LOCATION: SAN ONOFRE NUCLEAR GEN. STA., UNIT 1

P & I DIAGRAM
MISCELLANEOUS VENTILATION
SYSTEMS SHEET 2

5178621-2

CONFIGURATION CHANGE

Drwg. # 5178621-~~0~~² DR

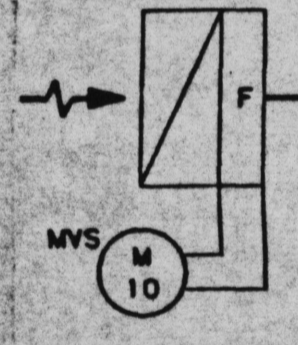
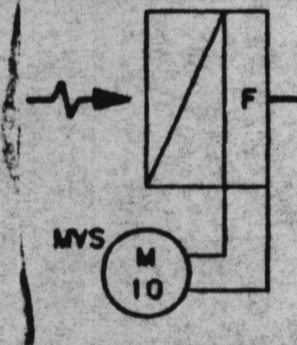
1. ADDED (WP 2.1.84) VENT HEADER, LINE # PAS-265-8" HP FROM HIGH RADIATION SAMPLING SYSTEM AS SHOWN ON SHEET 3 OF 3
